**SOLICITATION AMENDMENT**  
**MODIFICATION DE L'INVITATION**

| <b>Title - Sujet</b><br>Cell Modifications,Bldg B4,Dor.Pen   |   |
| <b>Solicitation No. - N° de l'invitation</b><br>EC016-131794/A   | <b>Amendment No. - N° modif.</b><br>005   |

**Modification numéro 5**

| project number<br>R.035149.001  |  | no. du projet<br>R.035149.001   |  | drawing no.<br>SK-1                                |  | no. du dessin<br>SK-1         |                      |

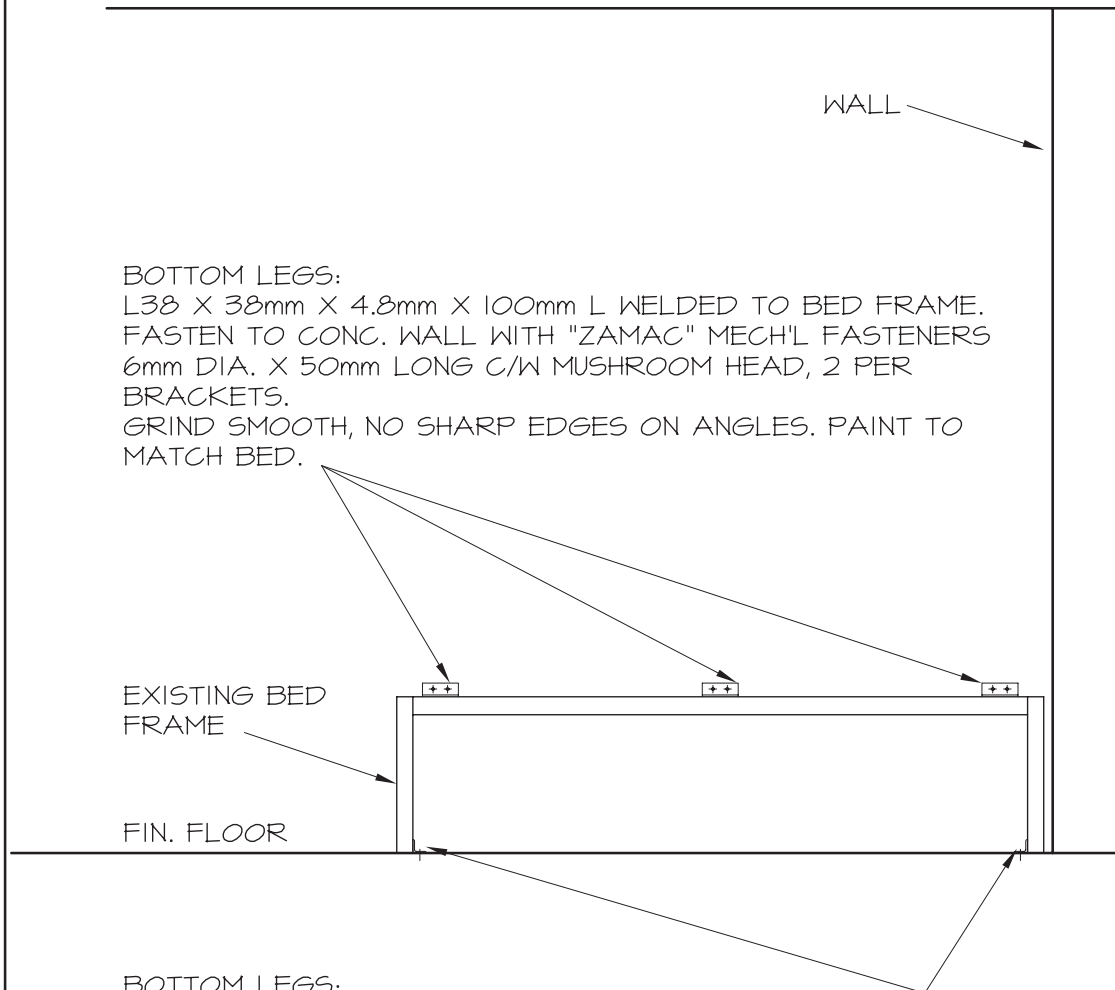
**Q1:** Will the existing beds and toilets need to be removed and reinstalled due to the removal and installation of the new flooring?

**Q7:** Are the cell beds to be removed prior to the installation of the new flooring?

NOTE,  
EXISTING BED TO BE REMOVED FOR NEW  
FLOOR TILE INSTALLATION. REINSTALL  
AS PER INFO BELOW.

**R1:** Toilets to remain, bed will have to be removed and reinstalled. See SK-1.

**R7:** Yes, see SK-1

BOTTOM LEGS:  
L38 X 38mm X 4.8mm X 100mm L WELDED TO BED FRAME.  
FASTEN TO CONC. WALL WITH "ZAMAC" MECH'L FASTENERS  
6mm DIA. X 50mm LONG C/W MUSHROOM HEAD, 2 PER  
BRACKETS.  
GRIND SMOOTH, NO SHARP EDGES ON ANGLES. PAINT TO  
MATCH BED.

BOTTOM LEGS:  
EXISTING ANGLE TO REMAIN, CUT EXISTING FASTENERS,  
DRILL NEW HOLES AND ATTACH WITH "ZAMAC" MECH'L  
FASTENERS 6mm DIA. X 50mm LONG C/W MUSHROOM HEAD  
3 PER SIDE MINIMUM.
